Bid Package Addenda #1:

Issued April 21st 2017

Municipal Garage Project
Town of Glover Vermont
April 21, 2017

SK1.1

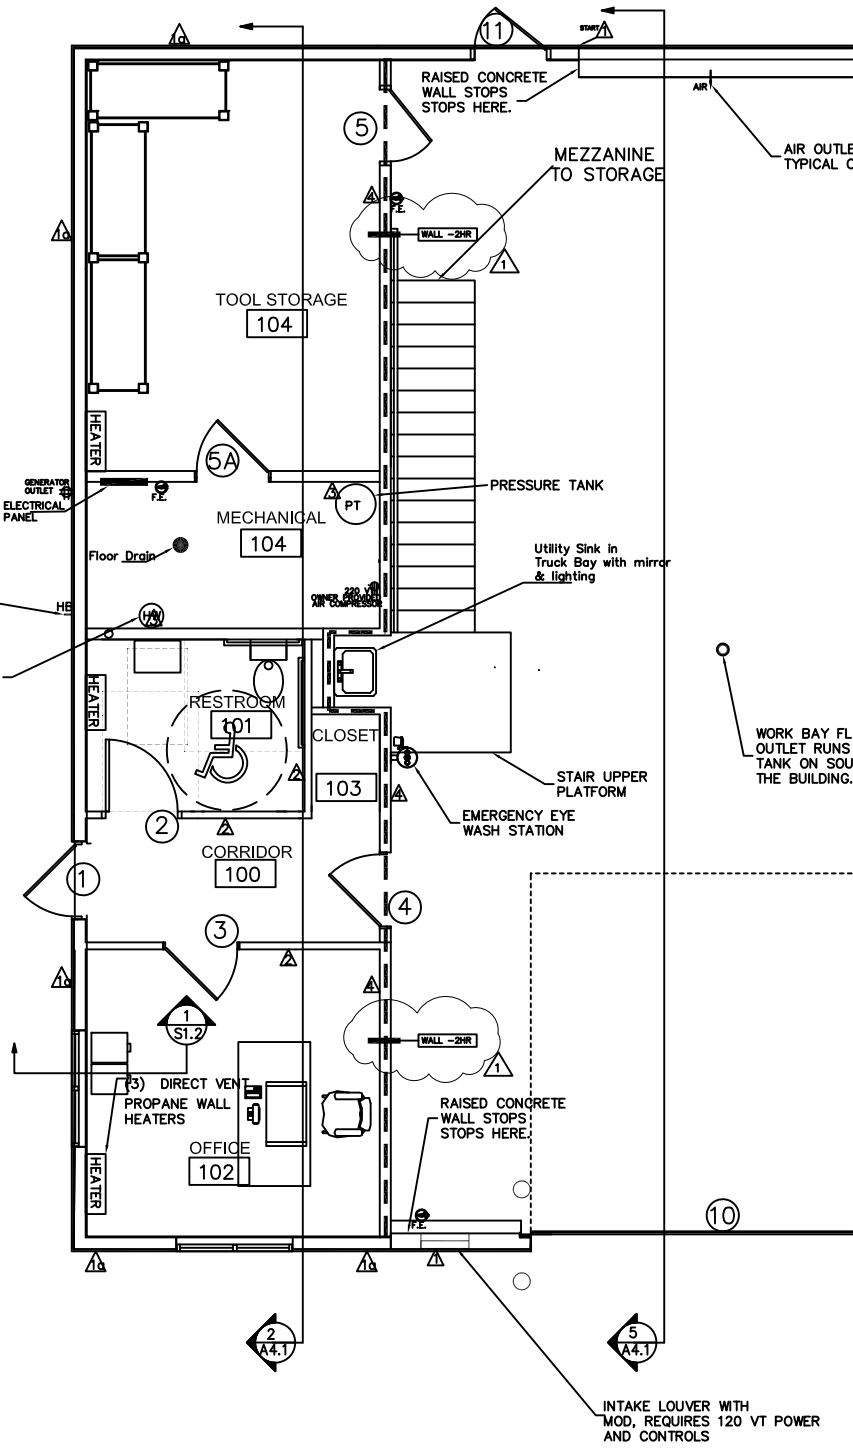
1. Code review requires a 2-hr separation between the enclosed office areas and the open garage. Please install 2-hr wall assembly and 2-hr Floor/Ceiling Assembly per attached SK1.1,SK1.2 and SK1.3

SK2.1

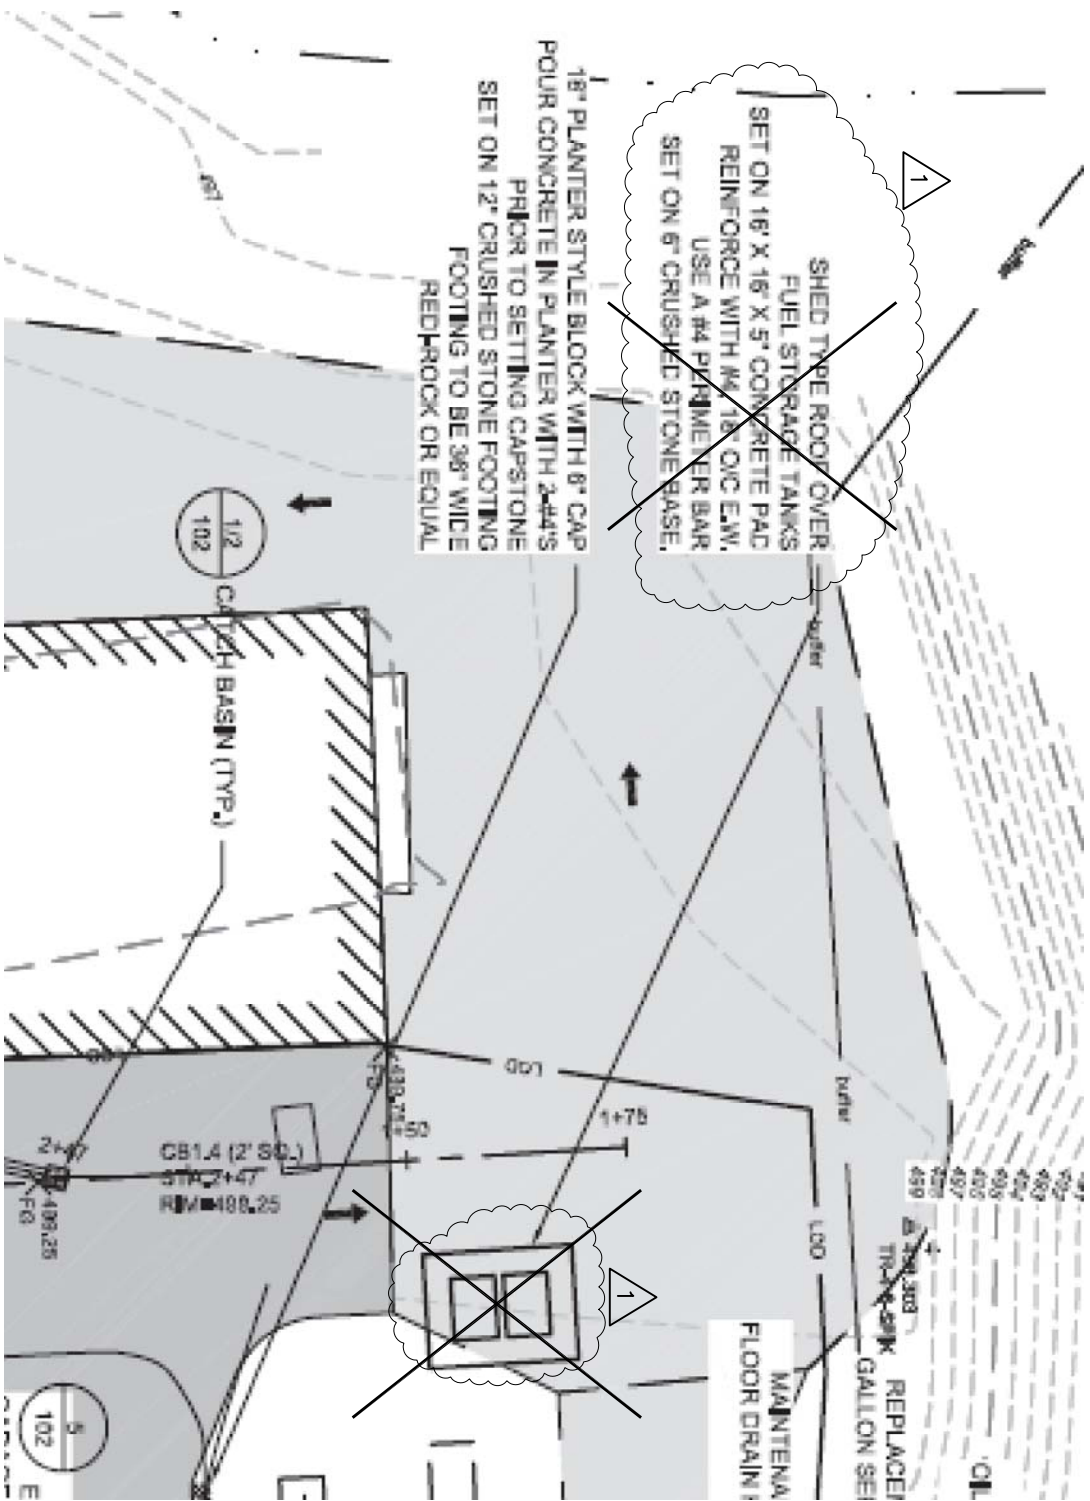
6. Plumbing drawings provided for design intent only. Plumbing shall be installed on a design build basis with the selected plumbing contractor providing the required design, engineering, permitting, and installation to meet applicable codes including required venting and components shown or not shown on the drawings. See SK2.1

ALL PLUMBING TO BE INSTALLED PER:
Vermont Plumbing Rules, 2015 edition
INCLUDING:
ICC International Plumbing Code, 2015 edition
PLUMBING DRAWING PROVIDED FOR DESIGN
INTENT ONLY. PLUMBING CONTRACTOR SHALL
BE RESPONSIBLE FOR FINAL DESIGN,
ENGINEERING & PERMIT INCLUDING ALL CODE
REQUIRED VENTING AND COMPONENTS SHOWN
OR NOT SHOWN ON THIS DRAWING.

SK3.1

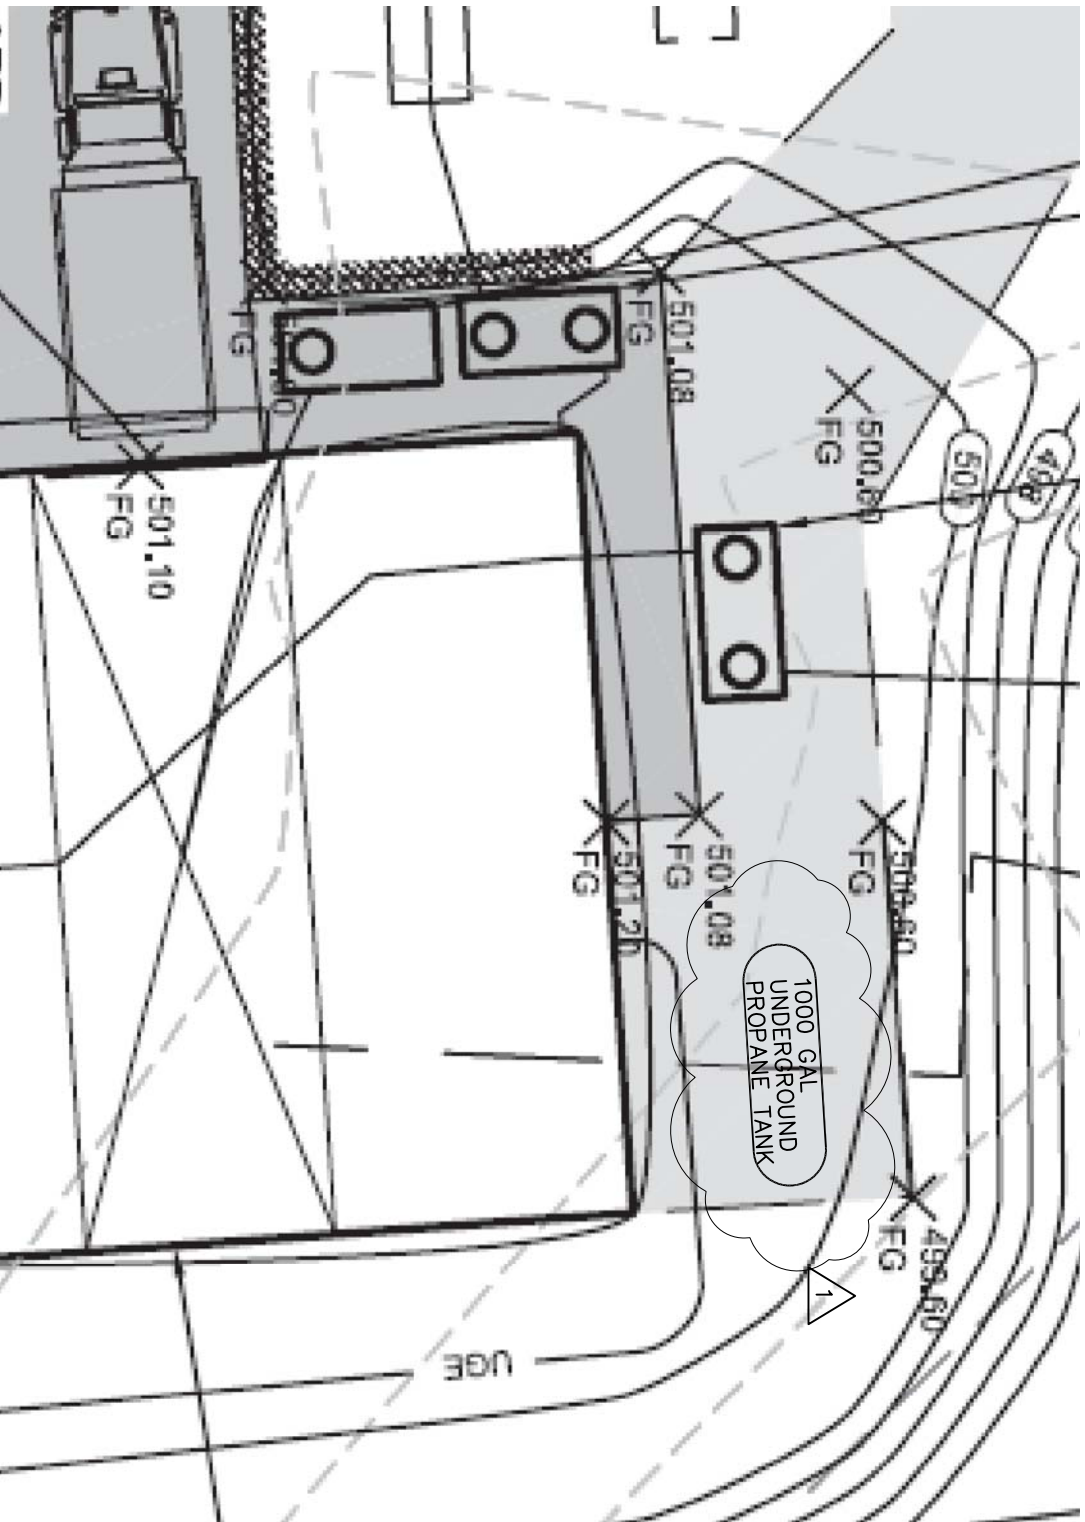
4. Eliminate Diesel fuel slab, shed, and electrical power supply. To be provided by Owner. See SK3.1

SK4.1

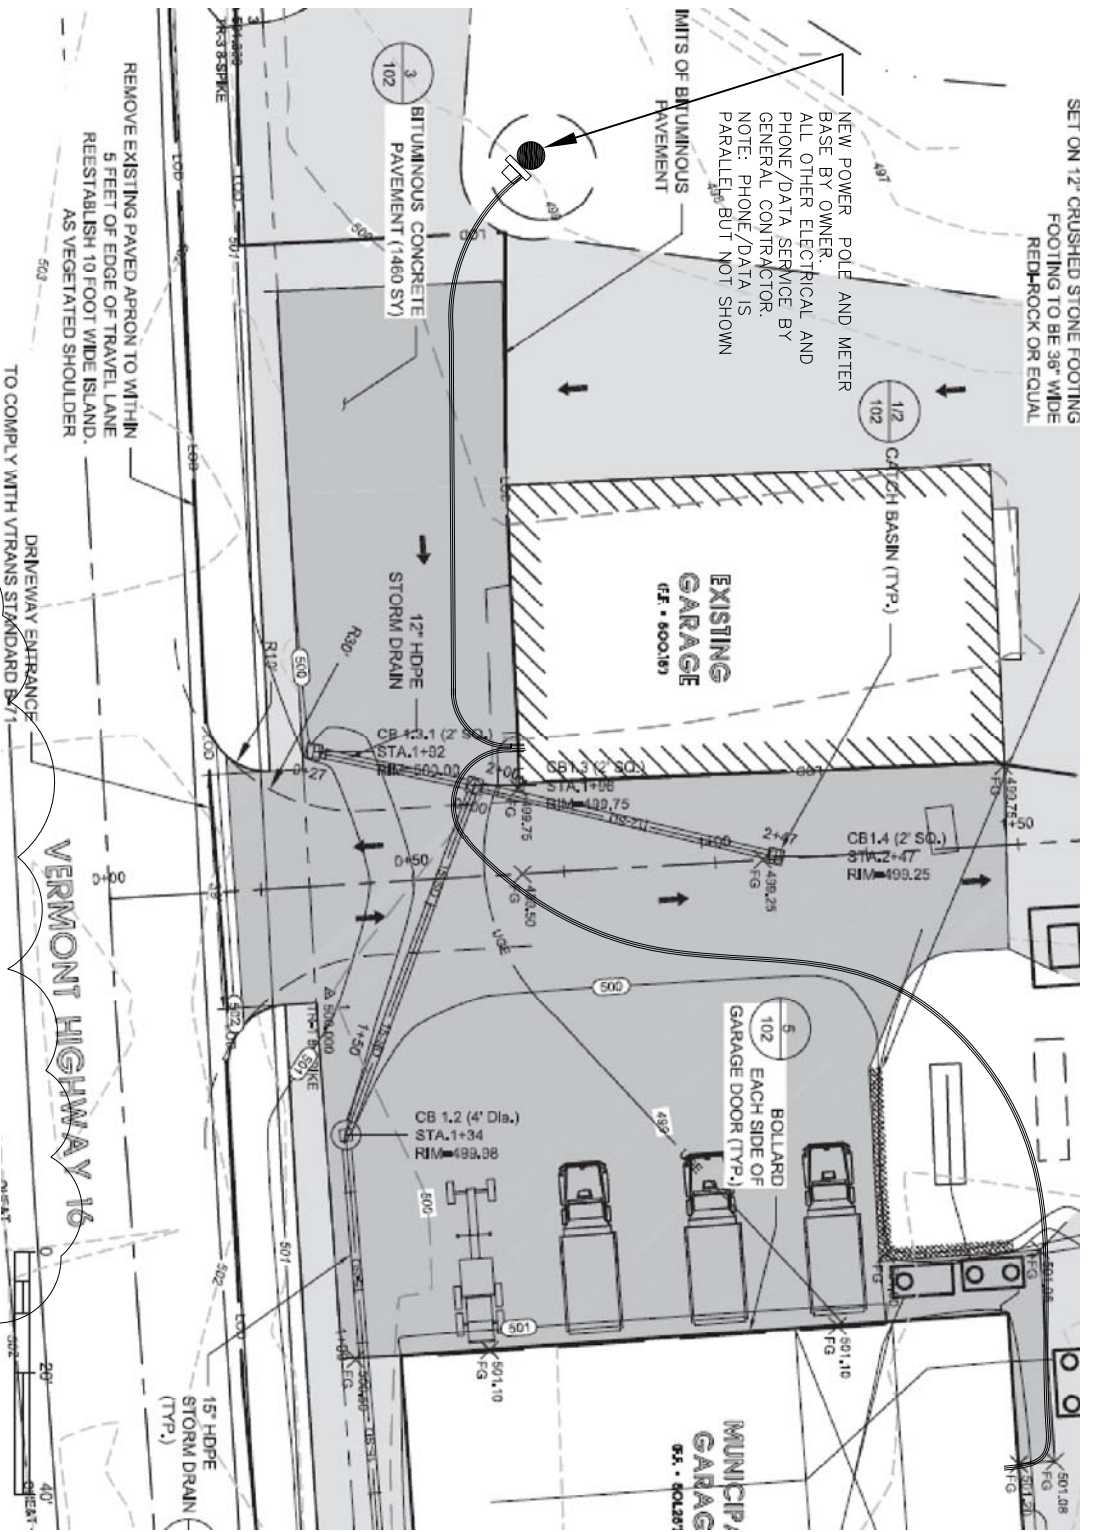
3. Soils testing and inspections shall be by Owner.
Concrete Slump and Compression testing shall be by Contractor.
4. The 1000 gallon underground propane tank to be located at the NW corner of the building – just north and aligned with the water oil separator. See SK4.1

Z512
12 [305] HEAVY-DUTY DRAIN

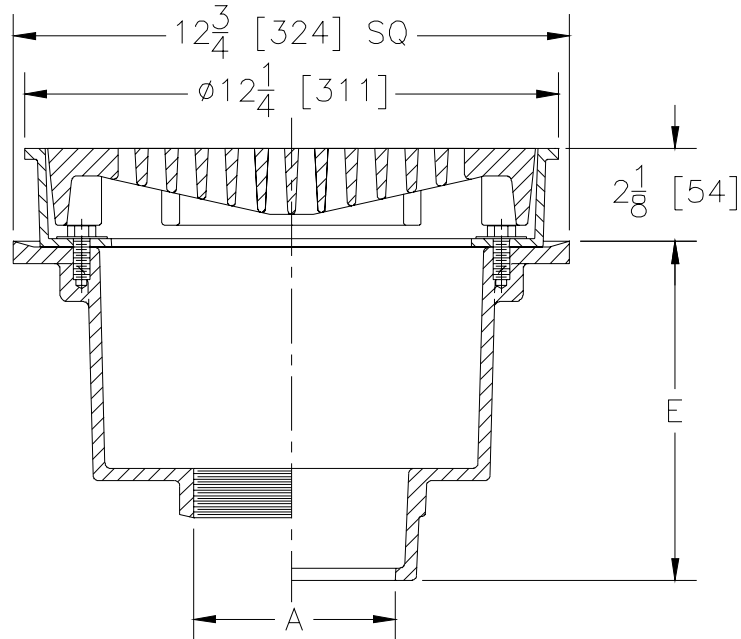
7. Please see attached Bid Form. Please prepare Bid on the attached form.
8. Work Bay Drain: Install Zurn Z512-Y deep sump heavy duty drain with bucket or approved equal – See cut sheet
